Report to Norwich Highways Agency Committee Item 26 March 2008

Subject Waiting Restriction requests for implementation in 2008/9

Waiting restrictions requests – results of Jan/Feb 2009 public consultation Norwich Highways Committee 26th March 2009

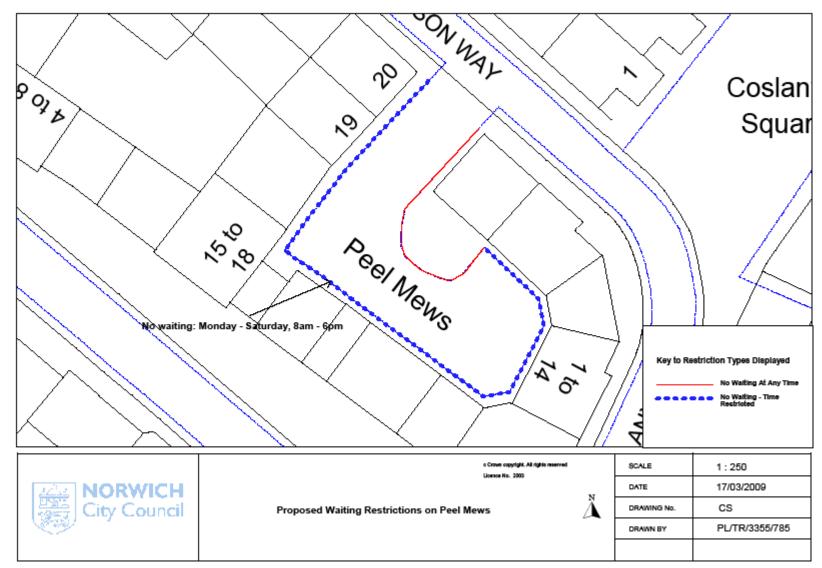
Location and summary	Comment	Officer comment
	Concerns that there is "no problem" from parking in Peel Mews. Suggests that private parking controls are sufficient deterrent. Queries if the yellow lines can be marked on the "kerbside" rather than back of building line. Concern that proposals would affect visitor parking. Petition signed by 8 householders Request that a single yellow line is introduced in front of the undercroft to allow some visitor parking.	was not implemented on the ground and this power has now lapsed. Permit parking was proposed for Peel Mews but was rejected by residents and NHAC. It not desirable to remove Peel Mews from the CPZ as this sets an inappropriate precedent for parking controls on adopted highway. Merely signing parking controls have proven to be ineffective. Private parking controls can only apply to non adopted land such as undercroft parking and is not applicable to adopted land. Legally enforceable parking controls are the only options we recommend. Implement single yellow lines, not double yellow lines as initially advertised. This is a lesser restriction and therefore does not require readvertisement. This proposal is shown on the plan attached as appendix B.
